RIVER PODDLE FLOOD ALLEVIATION SCHEME

Response to Request for Further
Information nos. 2 and 10

An Bord Pleanála Ref. 306725-20

14 SEPTEMBER 2020

Figure 2-1 – Plan of the modelled catchment

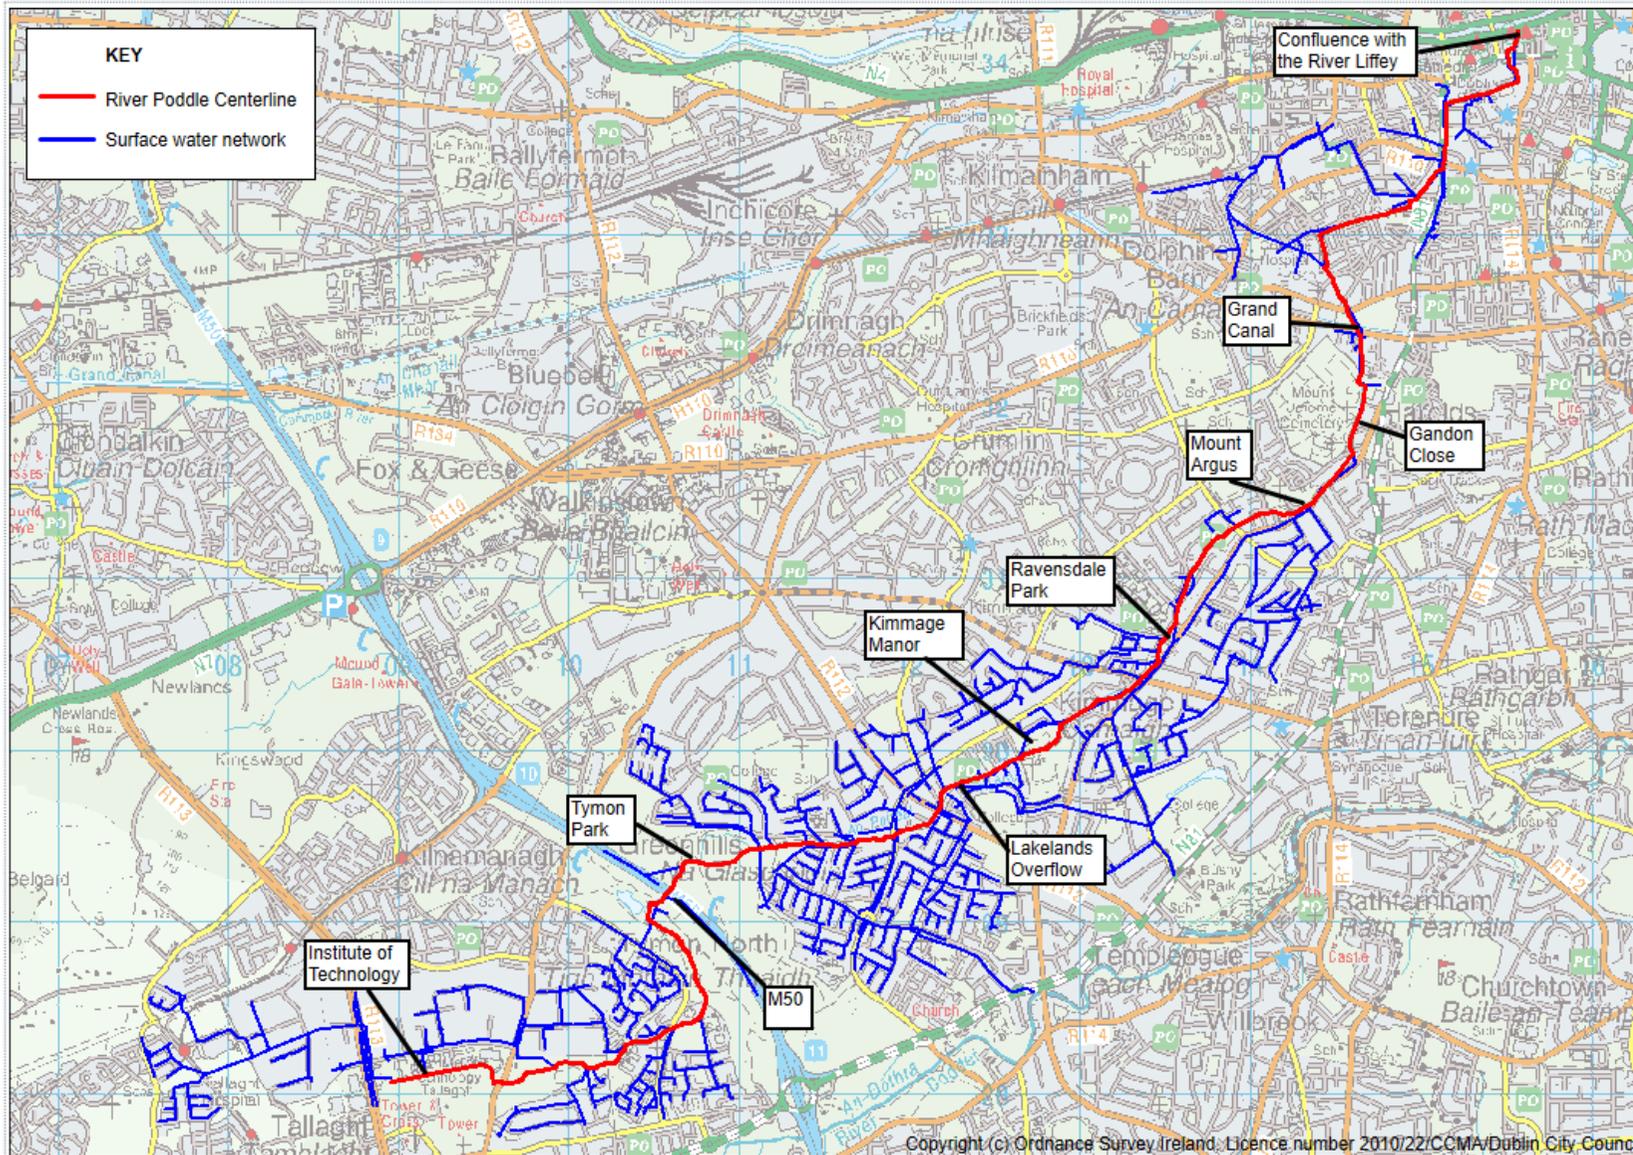
RFI no. 2. In responding to observations regarding natural flood management you are requested to:

- *include a brief description of the locations and volumes of water inputs to the Poddle*
- *comment on the option of increasing upstream storage at Tymon North or Tymon Park and at Ravensdale Park*
- *explain the design in terms of capacity to deal with blockage in culverts.*

The main sources of inflow to the river are from the surface water system. There is no rural contribution to the River Poddle. In response to **RFI no. 2**, Table 2-1 gives the inflow location, peak flow and volume during a 1% Annual Exceedance Probability (AEP) event. A 1% AEP is often referred to as a 1 in 100 year event. Flow and input locations are shown as blue lines on Figure 2-1.

Figure 2-1 shows the plan of the modelled catchment including key locations along the watercourse.
